RE: PZ# 24-12000027 MAJOR SITE PLAN - VERA / 1600 FEDERAL LLC (1600 S Federal Highway)

Thank you for providing us with comments at the March 5<sup>th</sup>, 2025 DRC Meeting. We would like to take the opportunity to respond to those comments issued from at this time. If you believe the comments have been satisfied and the project can move forward, please indicate so.

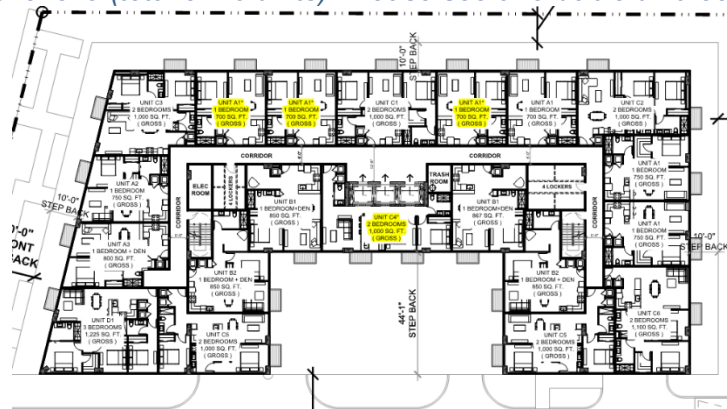
- (1) One or more of the affordable housing categories, as defined by this Plan, must be a component of the residential development based on the following bonus units to affordable unit formula(s) described below:
  - (a) Moderate income: six (6) bonus units for every (1) one moderate income unit.
  - (b) Low income: nine (9) bonus units for every (1) one low income unit.
  - (c) Very-low income: nineteen (19) bonus units for every (1) one very-low income unit.

*Understood, thank you. We propose 20 moderate income affordable units; 4 units per floor from level 5 to level 9 (total of 20 units). Please see affordable unit locations below:*
